# Access Compliance Report

## Public Rights-of-Way

Intersection ID: 46342	Main Street: BRANDYBUCK_LN	Cross Street: PRAIRIE_VALLEY_DR	Location: E
ADA ID: 7B4006B13EC6	Ramp Type: BlendTrans1	Initial Pass/Fail: Fail	Overall Compliance: No
Severity Score: 10			
Codes/Mitigation Info/Possible Solution		Field Measurements/Component Compliance

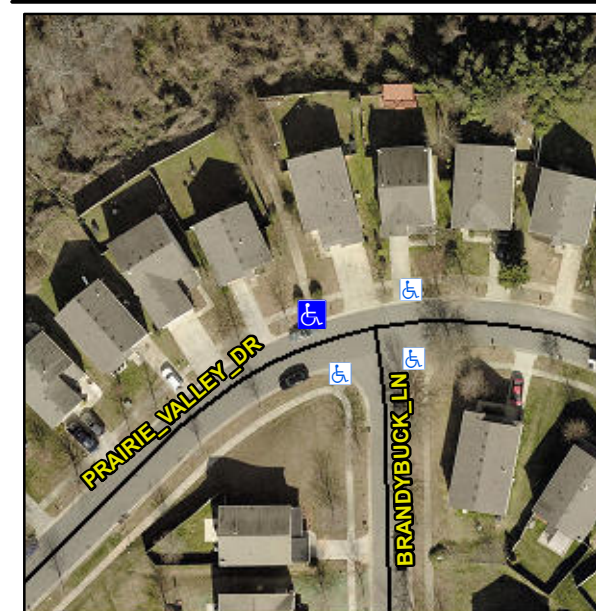
**Not Found, R304.5.1, R304.5.3**

Compliance	Description	Data	Compliance	Description	Data
N/A	Ramp Length (in)	84.0	Yes	BlendTrans Slope (%)	3.6
No	Ramp Width (in)	47.0	No	BlendTrans XSlope (%)	4.7
N/A	Flare Type LT	N/A	N/A	Flare Type RT	N/A
N/A	Flare Slope LT (%)	N/A	N/A	Flare Slope RT (%)	N/A
N/A	Flare Traversable LT?	N/A	N/A	Flare Traversable RT?	N/A
N/A	Landing Length (in)	N/A	N/A	DWS Provided?	N/A
N/A	Landing Width (in)	N/A	N/A	DWS Contrast?	N/A
N/A	Landing Slope (%)	N/A	N/A	DWS Length (in)	N/A
N/A	Landing X Slope (%)	N/A	N/A	DWS Full Width?	N/A
N/A	Landing Curb? (Y/N)	N/A	N/A	DWS Offset (in)	N/A
N/A	Shared Landing?	N/A			
N/A	Gutter Ponding?	N/A	N/A	Gutter Slope (%)	N/A
N/A	Gutter Lip Ht (in)	1.0	N/A	Gutter X Slope (%)	N/A
N/A	Painted X Walk1?	No	N/A	Painted X Walk2?	N/A
	X Walk 1 Direction	To SE		X Walk 2 Direction	N/A
	X Walk 1 Width (in)	N/A		X Walk 2 Width (in)	N/A
	X Walk 1 Slope (%)	4.6		X Walk 2 Slope (%)	N/A
	X Walk 1 X Slope (%)	2.2		X Walk 2 X Slope (%)	N/A

N/A	Ramp inside XWalk1?	N/A	N/A	Ramp inside XWalk2?	N/A
	Road Slope (%)	2.2		Clear Space?	N/A
	Road X Slope (%)	4.6	N/A	Clear Space to XWalk (in)	N/A
N/A	Any Obstructions?	N/A	N/A	Storm Grate/Utility Hazard?	N/A
	Obstruction Type			Storm Grate/Utility Type	
		N/A			N/A
			Yes	Surface Condition? (G/P)	Good
			No	Curb Slope (%)	11.9

**Remove & Replace Curb Ramp With Two New Directional Ramps or Equivalent.**
